# Access Compliance Report

## Public Rights-of-Way

Intersection ID: 44271	Main Street: BRITTNI_DAYLE_DR	Cross Street: TRAVIS_FLOYD_LN	Location:	N
ADA ID: 763F0D88BE53	Ramp Type: Perp	Initial Pass/Fail: Fail	Overall Compliance: No	Severity Score: 13.75
Codes/Mitigation Info/Possible Solution		Field Measurements/Component Compliance

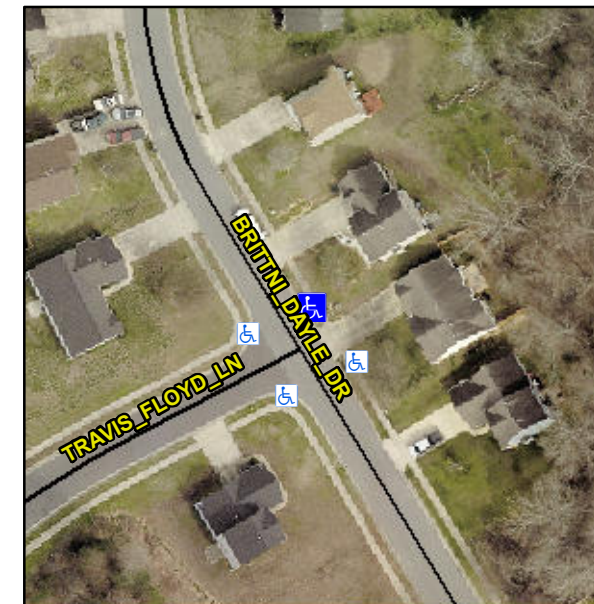
**Not Found, R304.2.2**

Compliance	Description	Data	Compliance	Description	Data
N/A	Ramp Length (in)	48.0	No	Ramp Slope (%)	9.2
Yes	Ramp Width (in)	50.0	Yes	Ramp XSlope (%)	4.2
N/A	Flare Type LT	N/A	N/A	Flare Type RT	N/A
N/A	Flare Slope LT (%)	N/A	N/A	Flare Slope RT (%)	N/A
N/A	Flare Traversable LT?	N/A	N/A	Flare Traversable RT?	N/A
N/A	Landing Length (in)	N/A	N/A	DWS Provided?	N/A
N/A	Landing Width (in)	N/A	N/A	DWS Contrast?	N/A
N/A	Landing Slope (%)	N/A	N/A	DWS Length (in)	N/A
N/A	Landing X Slope (%)	N/A	N/A	DWS Full Width?	N/A
N/A	Landing Curb? (Y/N)	N/A	N/A	DWS Offset (in)	N/A
N/A	Shared Landing?	N/A			
N/A	Gutter Ponding?	N/A	N/A	Gutter Slope (%)	N/A
N/A	Gutter Lip Ht (in)	N/A	N/A	Gutter X Slope (%)	N/A
N/A	Painted X Walk1?	No	N/A	Painted X Walk2?	N/A
	X Walk 1 Direction	To SW		X Walk 2 Direction	N/A
N/A	X Walk 1 Width (in)	N/A	N/A	X Walk 2 Width (in)	N/A
	X Walk 1 Slope (%)	2.5		X Walk 2 Slope (%)	N/A
	X Walk 1 X Slope (%)	5.4		X Walk 2 X Slope (%)	N/A

**Remove & Replace Entire Ramp.**
